# ADDENDUM NO. 1

## VILLAGE OF ELDORADO WWTP ALTERATIONS – PHASE I CONTRACT ‘C’

This addendum forms a part of the Contract Documents and modifies the original Contract Documents dated April of 2011. Acknowledge receipt of this Addendum in space provided on the Bid Proposal form. Failure to do so may subject the Bidder to disqualification.

# STEEL INLET TROUGH DETAIL

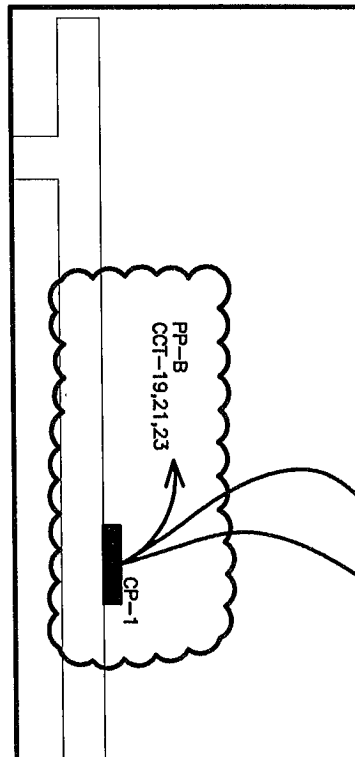
6. The “Steel Inlet Trough Detail” located on Sheet 3 of 5 of the engineering plan set has been updated from the original plan set.
  - a. The proposed 10” deep x 6” tall x 3” wide x ¼” thick A-36 painted steel brackets have been changed to 9” deep x 9” tall x ¼” thick A-36 painted steel knife connections. These proposed connections are to be welded to the proposed steel wall and proposed inlet trough at 12” O.C.

- b. The updated “Steel Inlet Trough Detail” has been attached as Exhibit ‘E’.
7. The “Electrical Plan and Schedules” sheet, Sheet 5 of 5 of the engineering plan set, has had several modifications which are listed below:

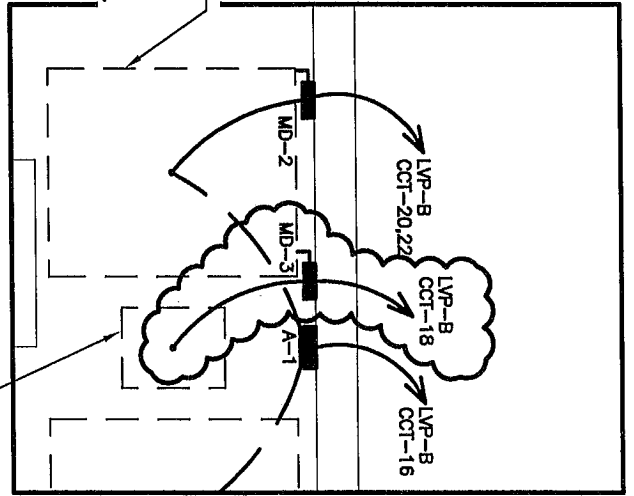
- a. The original main disconnects, MD-3 and MD-4, have been removed. The proposed wastewater pumps are both wired from the proposed control panel, CP-1. This change is reflected on the updated panel schedule for Panel PP-B and on Sheet 5 of 5 of the engineering plan set. These changes are attached as part of Exhibit ‘F’.

- b. The proposed main disconnect, MD-3, which is now the disconnect for the refrigerated dryer equipment and NOT for wastewater pump #1, has been added and this change can be reflected on the updated panel schedule for Panel LVP-B and on Sheet 5 of 5 of the engineering plan set. These changes are attached as part of Exhibit ‘F’.

- c. Both panel schedules, PP-B and LVP-B, have been updated along with the Electrical Legend to match the updates made to the “Tertiary Filter Unit Power Plan.”

PROPOSED AIR COMPRESSOR #2.  
IF REQUIRED BY SAND FILTER  
MANUFACTURER, SUPPLIED BY  
SAND FILTER MANUFACTURER, SEE  
DESIGN DATA ON SHEET 4 OF 5  
FOR COMPRESSOR SPECIFICATIONS.

PROPOSED REFRIGERATED DRYER, SUPPLIED  
BY SAND FILTER MANUFACTURER, SEE  
DESIGN DATA ON SHEET 4 OF 5 FOR  
DRYER SPECIFICATIONS.

## POWER RISER DIAGRAM

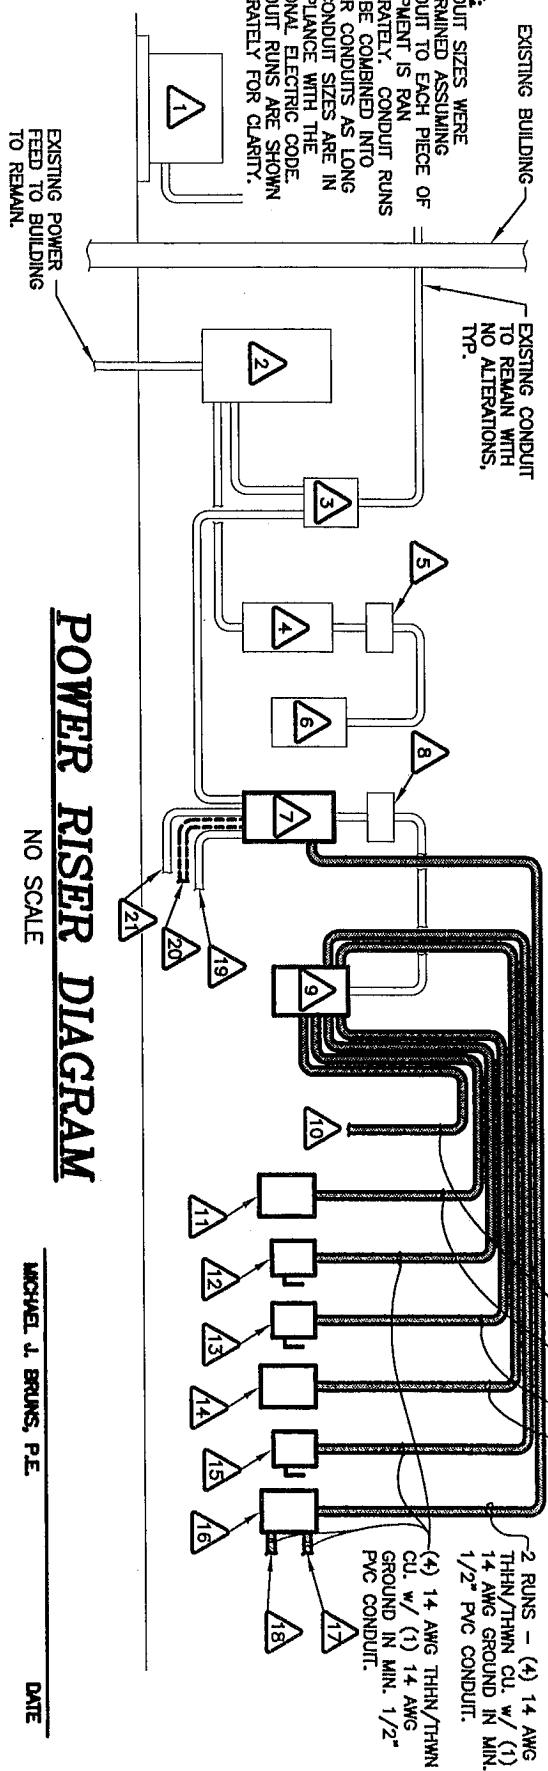
- e. A Power Riser Diagram has been attached to Sheet 5 of 5 of the engineering plan set. The Power Riser Diagram shows the alterations being made to the existing power panels and the type and size of the conductors and conduits required for the proposed equipment. These changes are attached as part of Exhibit ‘F’.

ALL ELECTRICAL WIRING IS TO BE RAN IN PVC CONDUIT. PLEASE REFER TO THE POWER RISER DIAGRAM (ADDITIONAL SHEET ATTACHED) FOR CONDUCTOR AND CONDUIT SIZES.

**NOTE:**  
CONDUIT SIZES WERE DETERMINED ASSUMING CONDUIT TO EACH PIECE OF EQUIPMENT IS RAN SEPARATELY. CONDUIT RUNS MAY BE COMBINED INTO FEWER CONDUITS AS LONG AS CONDUIT SIZES ARE IN COMPLIANCE WITH THE NATIONAL ELECTRIC CODE. CONDUIT RUNS ARE SHOWN SEPARATELY FOR CLARITY.
